GOVERNMENT OF THE DISTRICT OF COLUMBIA
OFFICE OF PLANNING

MEMORANDUM

SUBJECT: Final Report – Zoning Commission Case No.06- 14
Consolidated Planned Unit Development
Square 3584, Lots 23, 811-813 New York and Florida Avenues, NW
“Washington Gateway”

DATE: November 20, 2006

Illustration 1: Proposed Site Plan

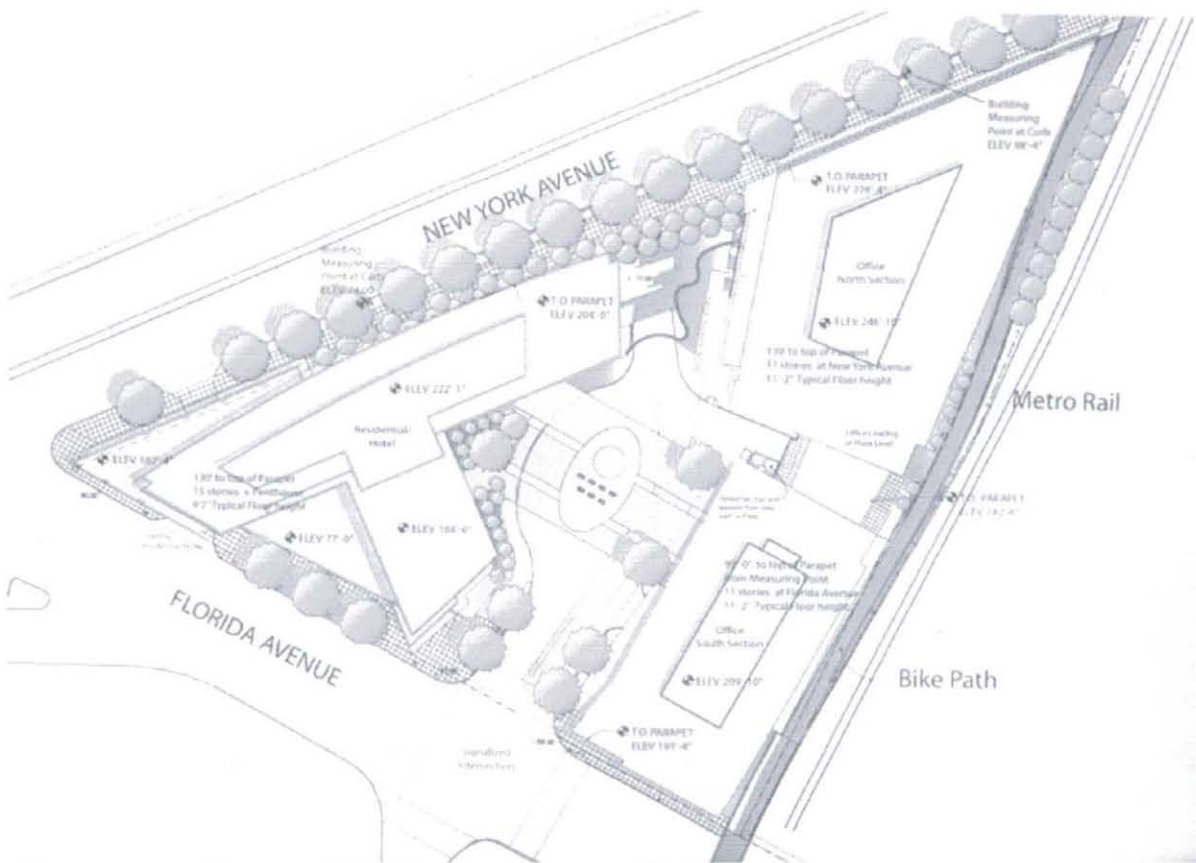
The above site plan is taken from Sheet 101 of the Applicant's November 9, 2006 filing. The applicant proposes to construct a mixed use development consisting of:

- One office building on the eastern side of the site, stretching from New York Avenue on the north to Florida Avenue on the south;
- A residential/hotel building on the western side of the site. The hotel and residences would be vertically separated and would have separate entries;
- A landscaped central plaza that could be entered from Florida Avenue, New York Avenue, or from an applicant-upgraded segment of the Metropolitan Branch (bicycle) Trail (MBT), which borders the site on the east.

The buildings would be on separate record lots. There would be 7,000 square feet of ground floor retail. The design is modern -- mixing glass curtain walls, aluminum and masonry. The site plan is intended to suggest the extension of the existing street grid, and is intended to be very open to the public from all three sides.
